I-66 North Bypass

VALUE ENGINEERING STUDY
for the
Kentucky Transportation Cabinet

Final Report

February 6, 2003

SKETCH OF ORIGINAL DESIGN

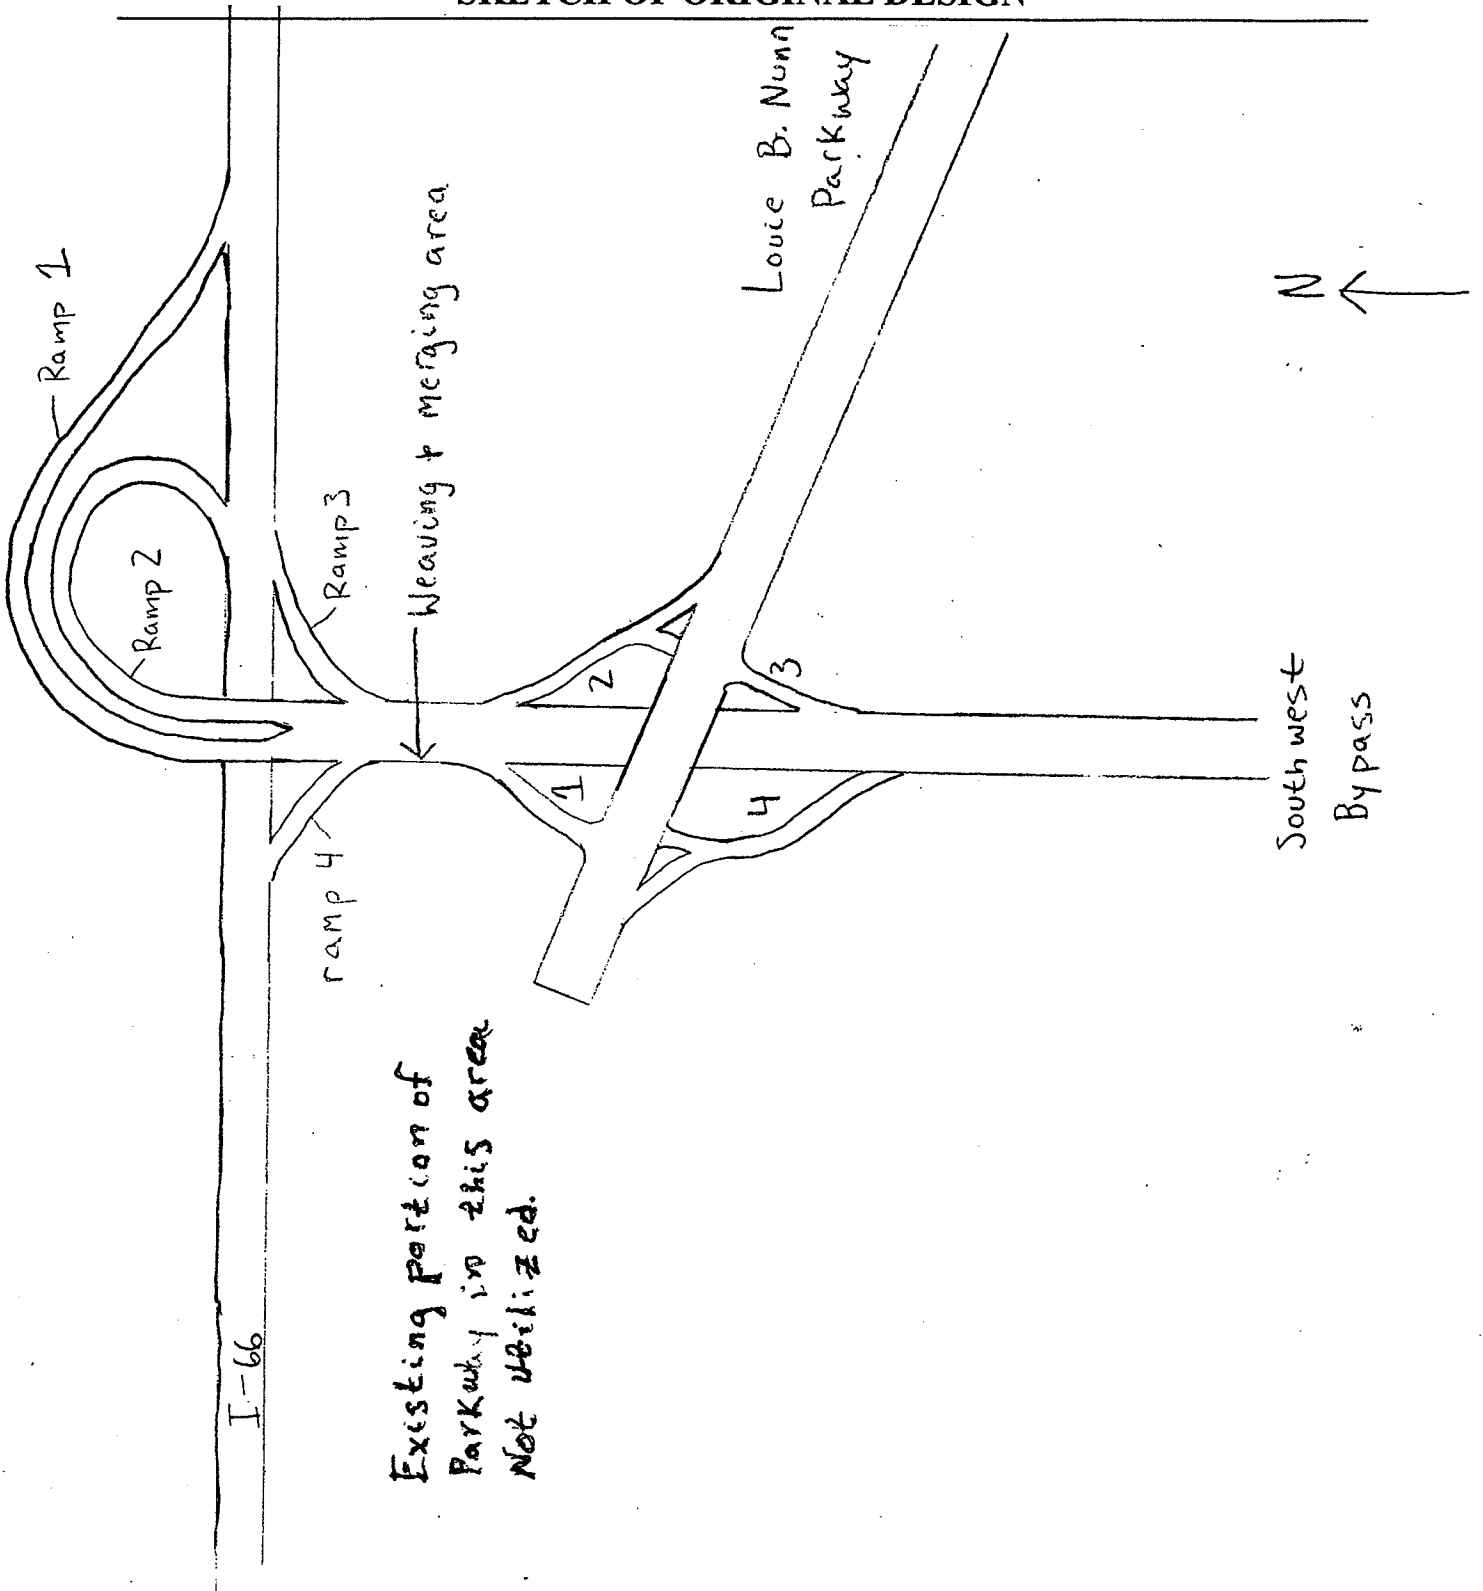
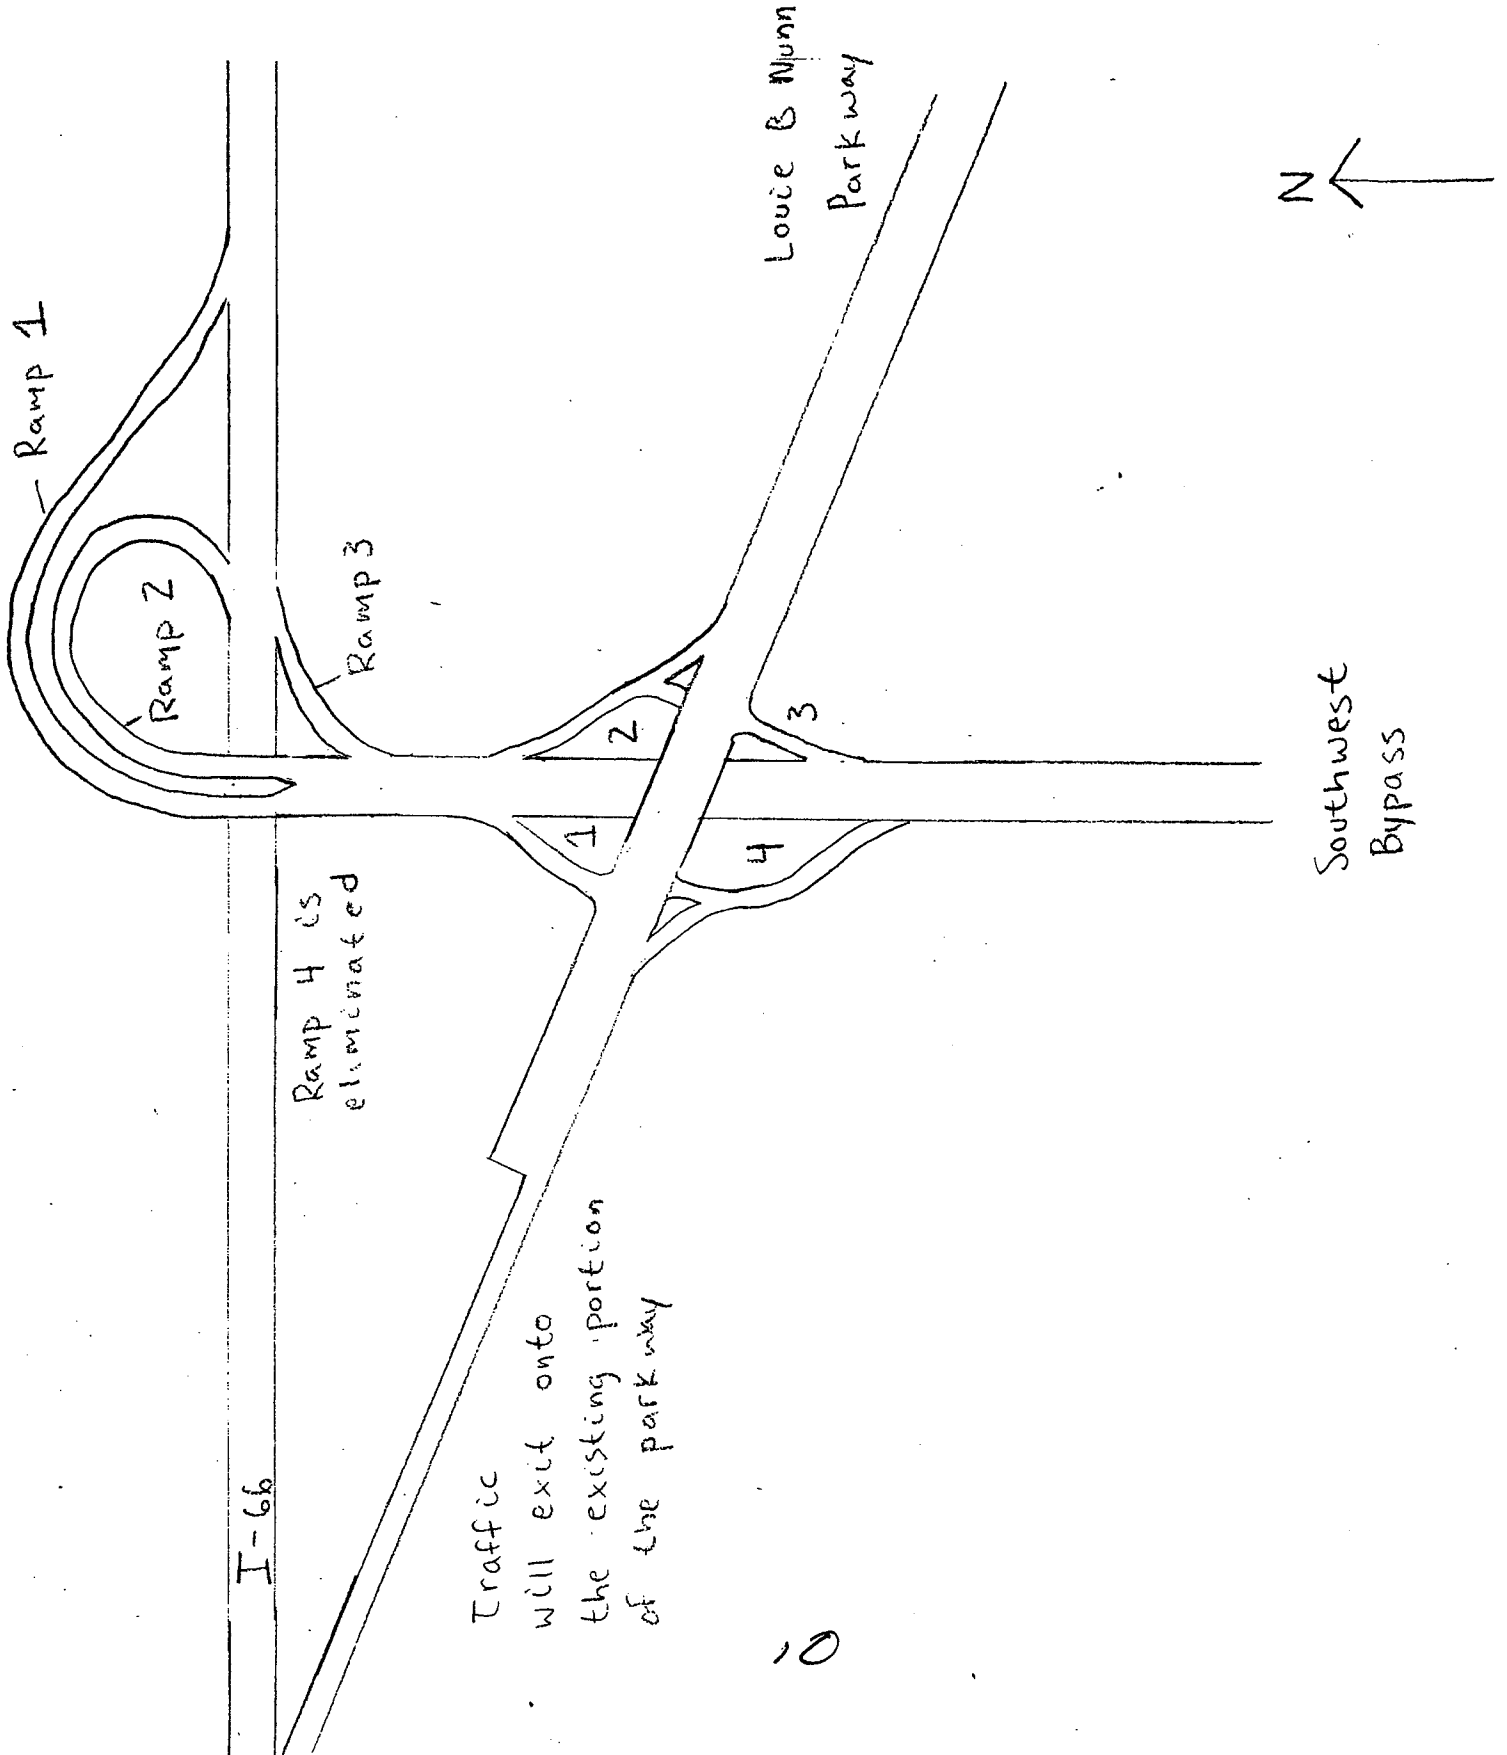
East bound I-66 traffic will exit to the southwest by-pass through ramp # 4. The new alignment for I-66 ties into the Louie B. Nunn Parkway which will also tie into the southwest by-pass at a grade separated interchange. The portion of the Louie B. Nunn Parkway between I-66 and the southwest by-pass will not be utilized.

Eliminate ramp # 4 and utilize the Louie B. Nunn Parkway as an exit ramp which will provide access to the southwest by-pass at the grade separated interchange.

The proposal would create an outer loop connection for eastbound I-66 traffic onto the southwest by-pass, eliminating a dangerous merging and weaving area on the by-pass. This, coupled with the estimated cost savings, indicates that the proposal should be reviewed further.

TYPICAL SECTION

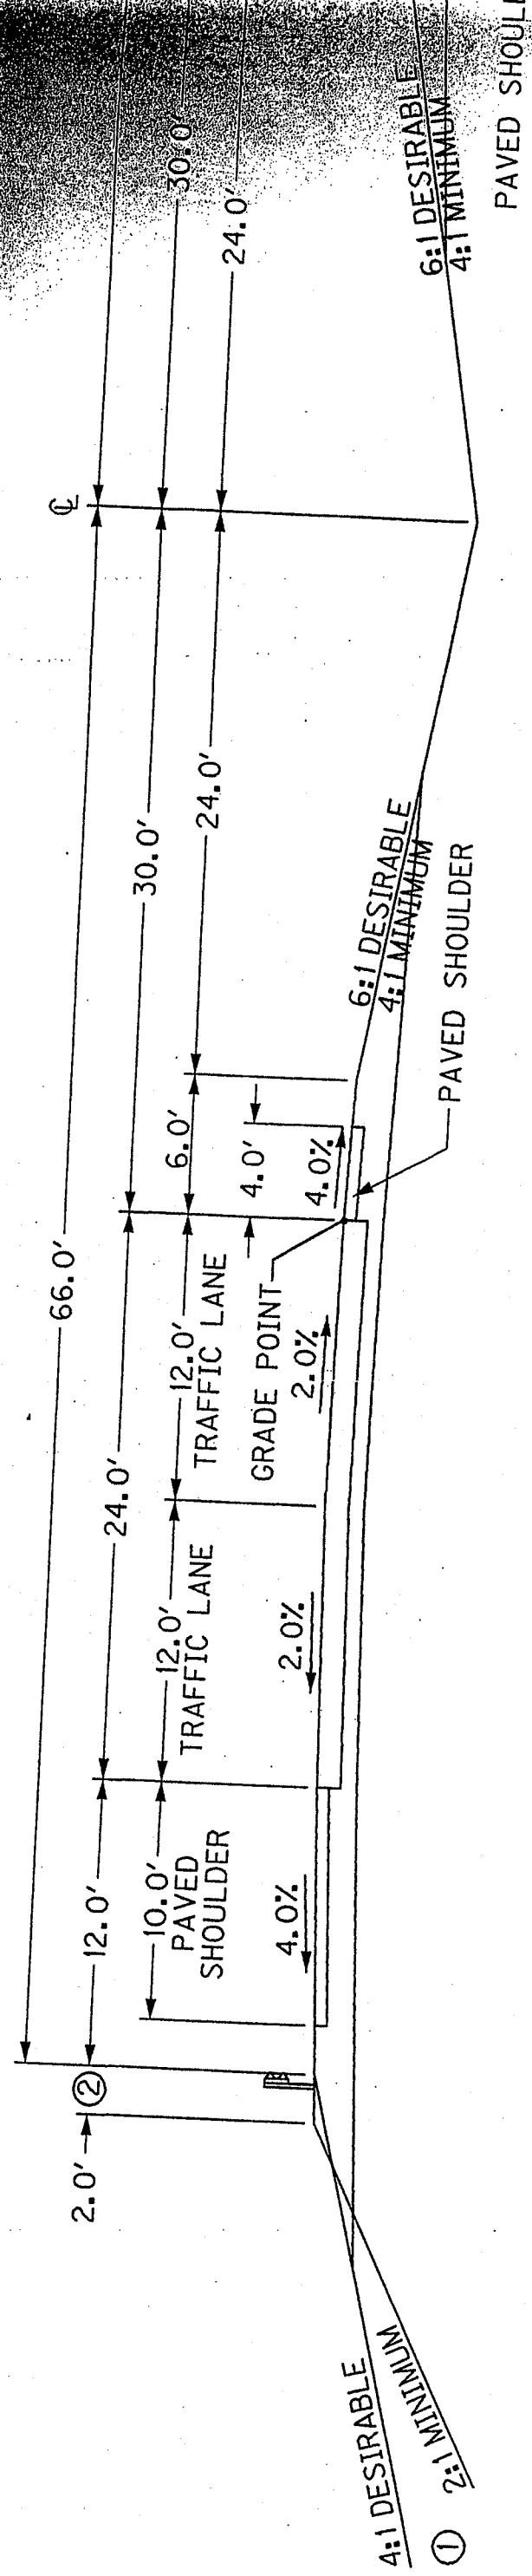
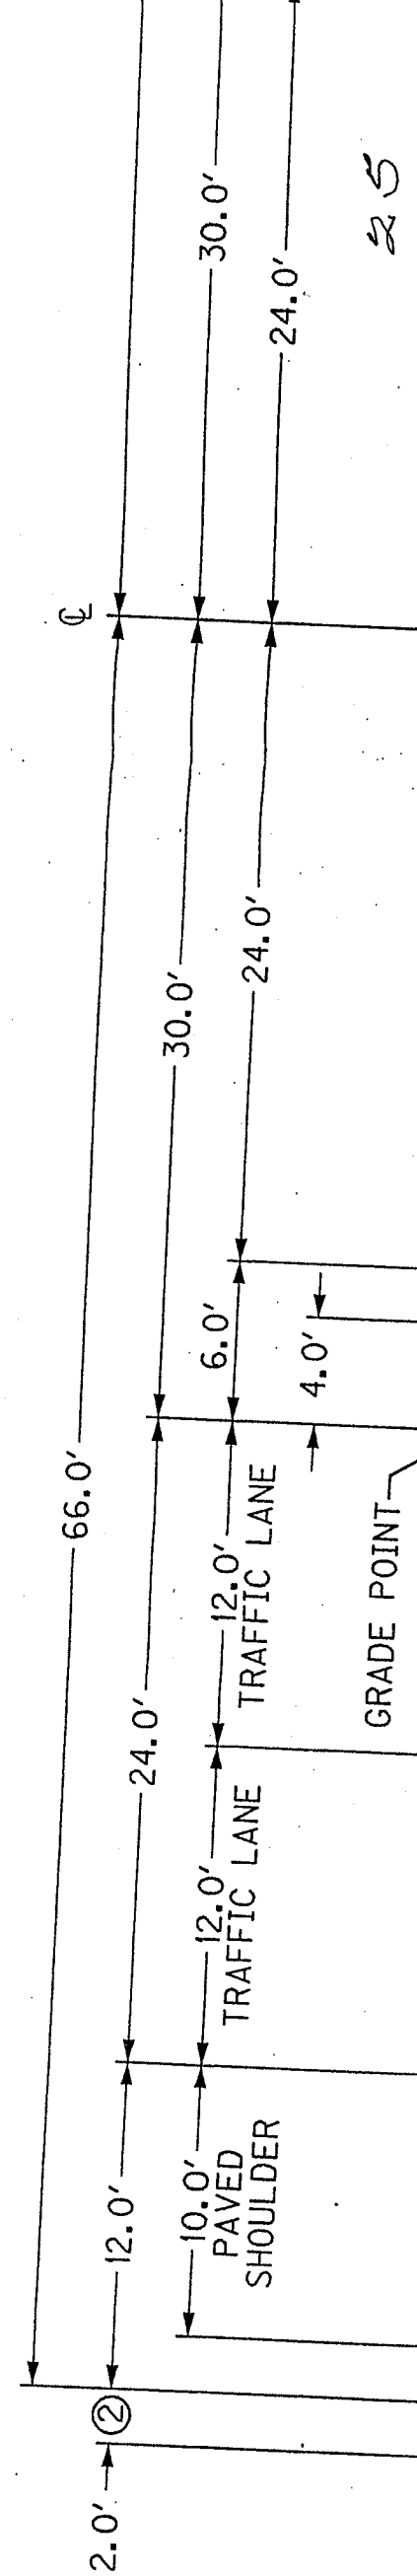
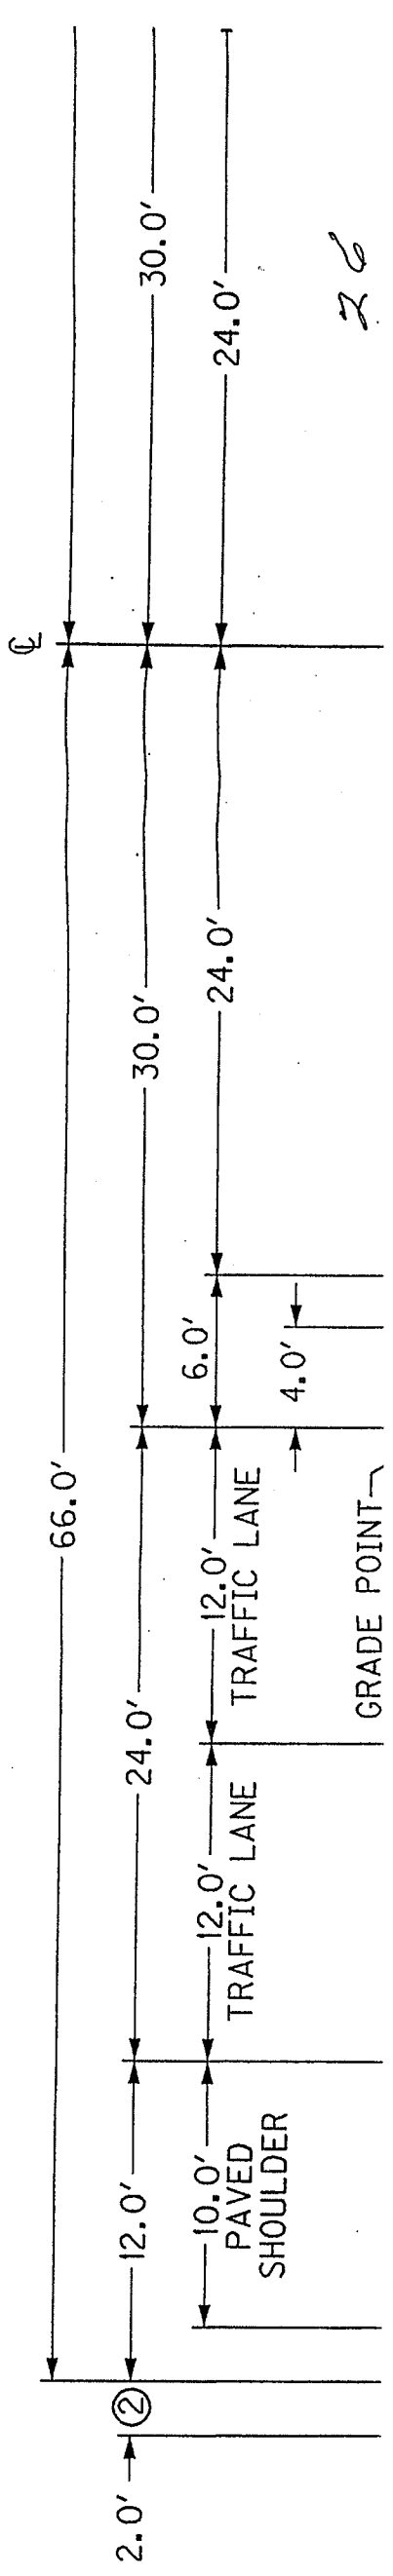
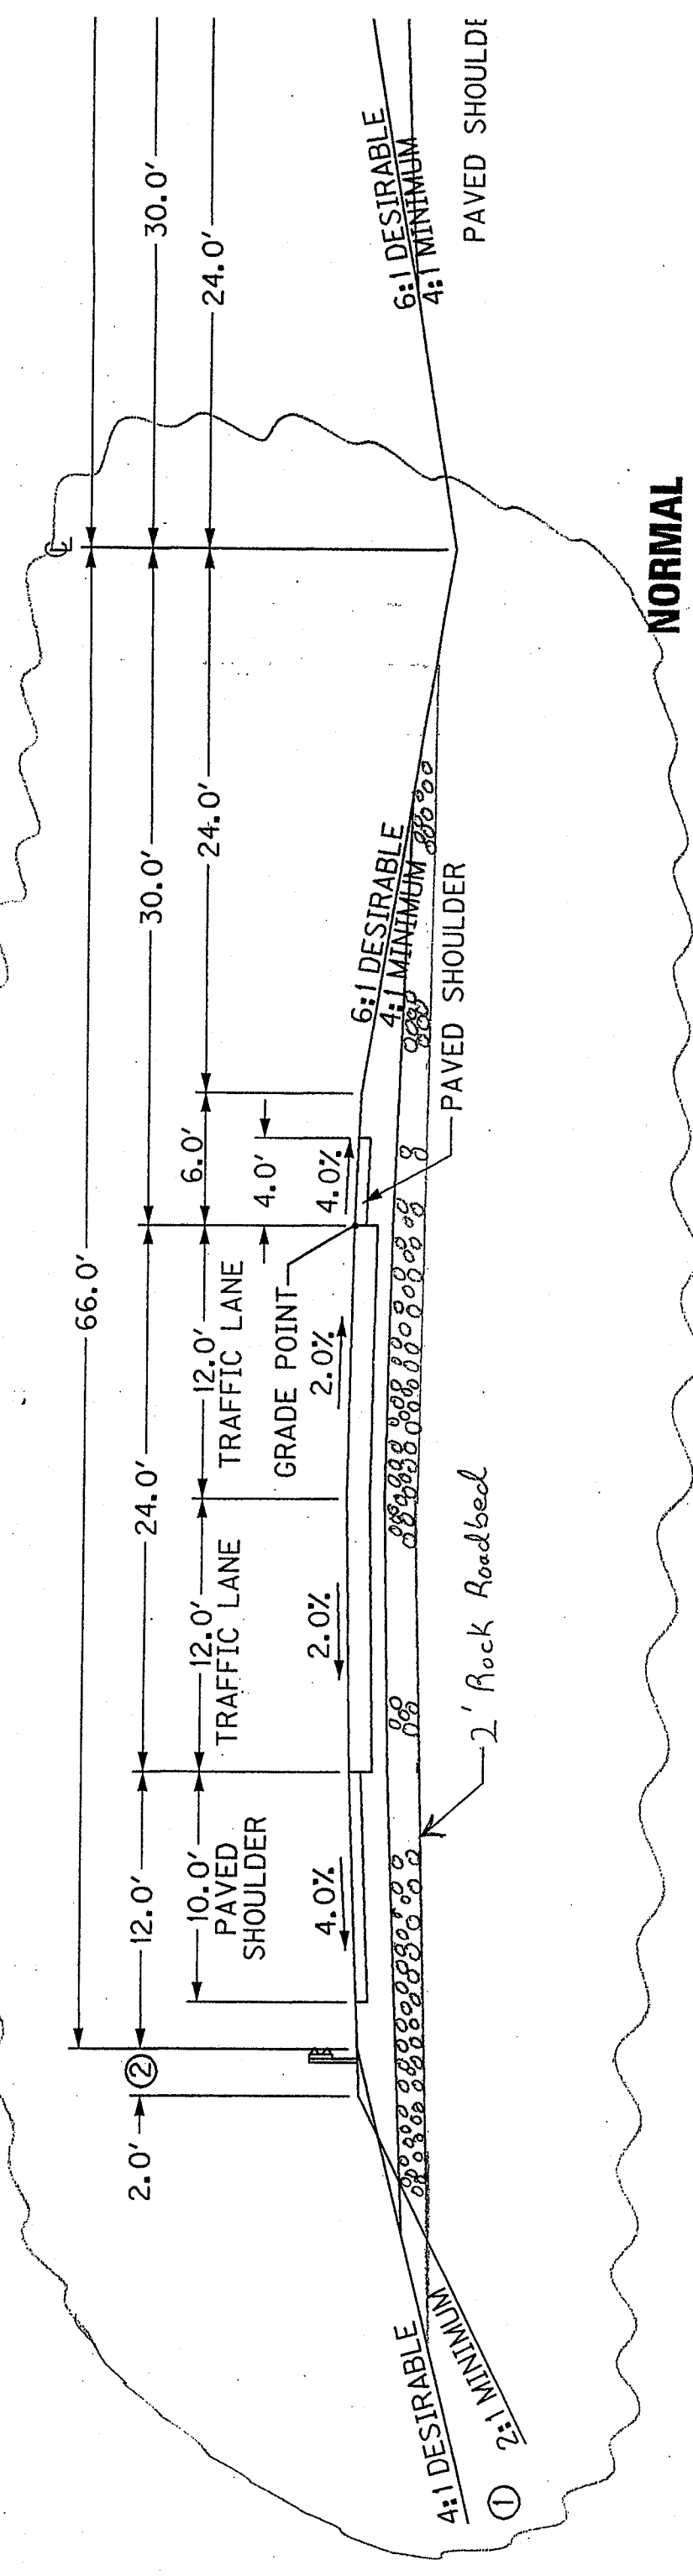
ORIGINAL DESIGN:
The design currently does not specify rock roadbed for the subgrade in the JDQ Section

RECOMMENDED CHANGE:
Providing there is enough good quality rock ($SDI \geq 95$) that could be generated on the project, a rock roadbed could be specified to reduce the amount of pavement thickness. Two feet of rock roadbed would eliminated four inches of bituminous base.

If this project has waste, it will require 174,074 cubic yards of rock to place a two foot rock roadbed. With this type of subgrade, approximately four inches of bituminous base can be eliminated at a savings of approximately \$ 882,000.

It is recognized that this project is an embankment in place project requiring the contractor to borrow material. This area is known to have good quality limestone. However, the borings would need to be studied closely to determine if mud seams or voids exist in the rock. An evaluation of the available rock would have to be made to determine if it is economically feasible to process to the required gradation. An additional \$0.25/C.Y. was added to the cost of rock roadbed to account for the possible increased cost for processing.
